Comments #148, #150 PLCA / D-PLCA Variable Ranges

IEEE 802.3da Interim January 2025

plca_node_count

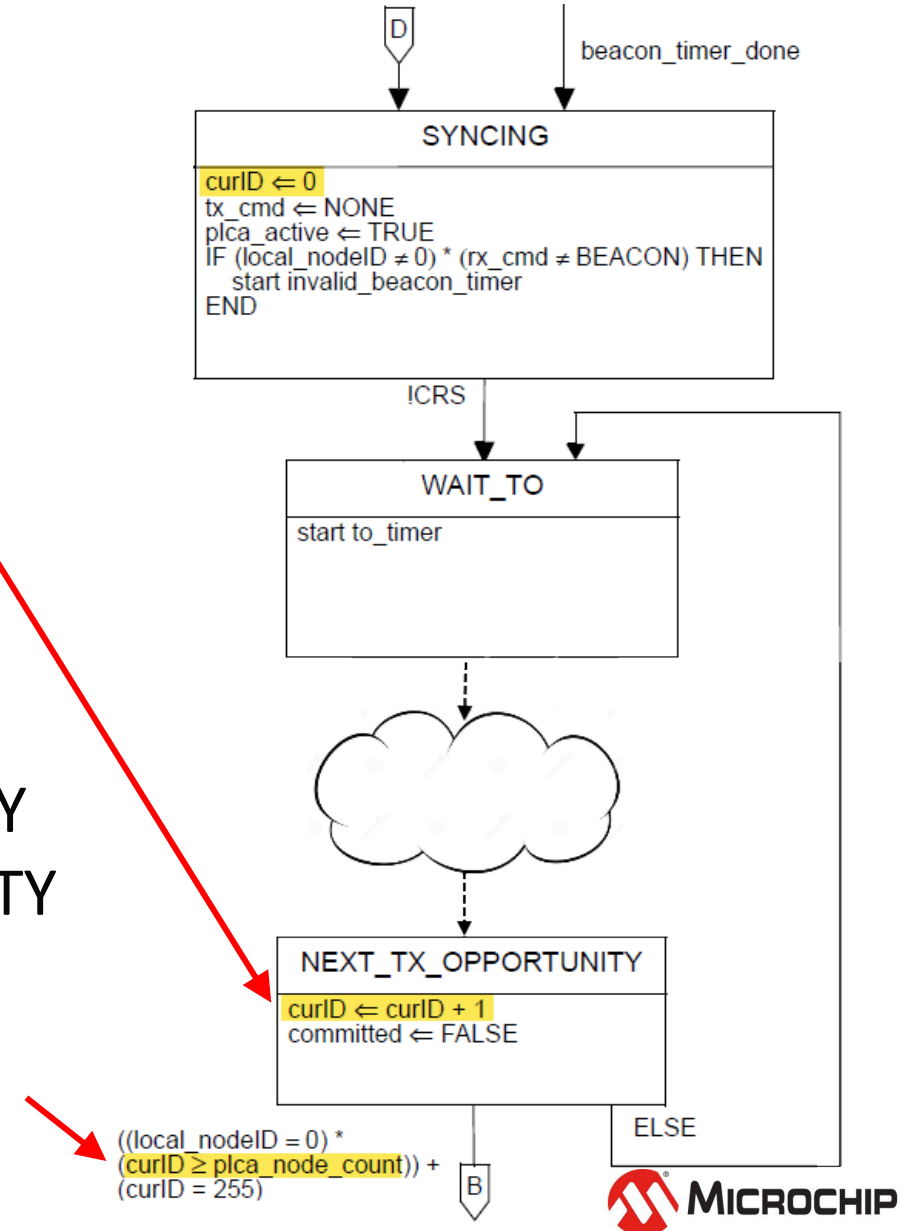
Maximum number of PLCA nodes on the mixing segment receiving transmit opportunities before the node with local_nodeID = 0 generates a new BEACON, reflecting the value of aPLCANodeCount. This parameter is meaningful only for the node with local_nodeID = 0; otherwise, it is ignored. ¹

Values: integer number from ~~0~~¹ to 255

- **As defined, a PLCA cycle with zero Transmit Opportunities makes no sense!**

Change: "Values: integer number from 0 to 255"

To: "Values: integer number from **1** to 255"

How many TO? Nodes?

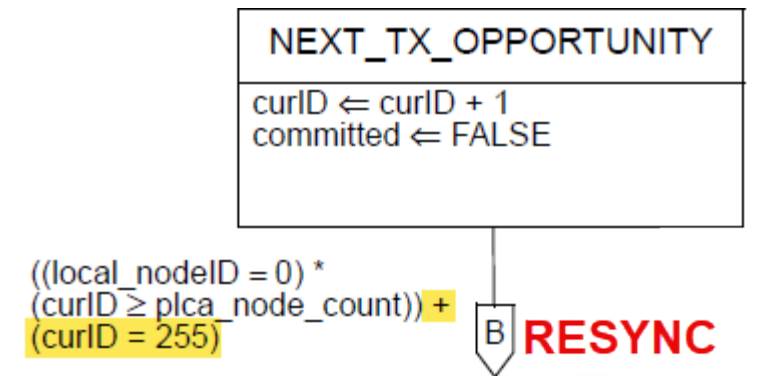
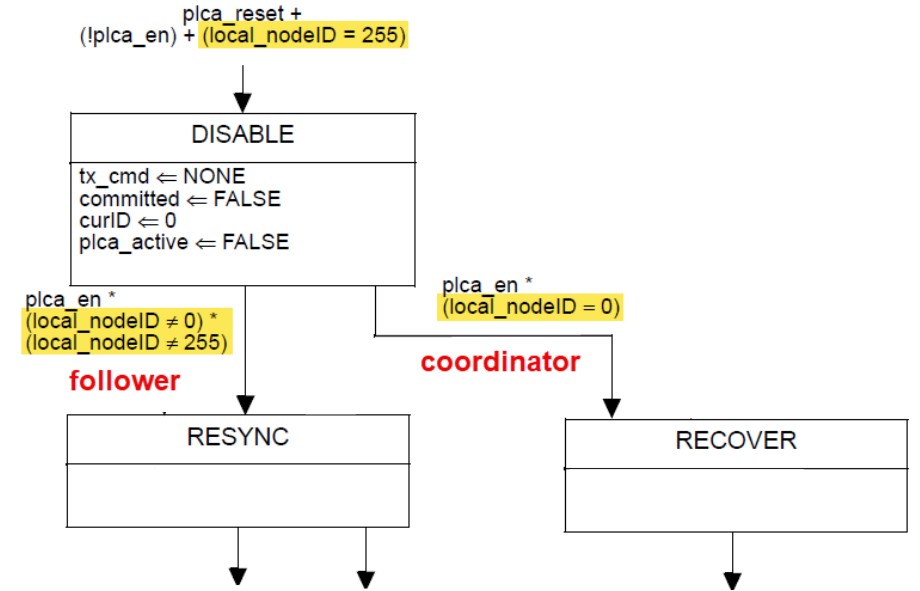
- **Setting aPLCANodeCount and plca_node_count to 0 results in one transmit opportunity, curID=0 or TO 0**
 - Do not exit until curID increments by 1
- **When Node Count is set to 255 Transmit Opportunities, TO 0 – TO 254, curID will range:**
 - from 0 to 254 on **entry** to NEXT_TX_OPPORTUNITY
 - from 1 to 255 on **exit** from NEXT_TX_OPPORTUNITY
 - Exit to RESYNC when $\text{curID} \geq \text{plca_node_count}$
 - Else, to WAIT_TO for next transmit opportunity

- There are only 255 TO, identified as TO 0 through TO 254
 - This accommodates up to 255 nodes
- Can there be a TO of 255?
 - No. Assigning a node as localID=255 disables PLCA with global transition
- When curID is incremented to 255 in NEXT_TX_OPPORTUNITY, transition to RESYNC (not shown) to send to BEACON.
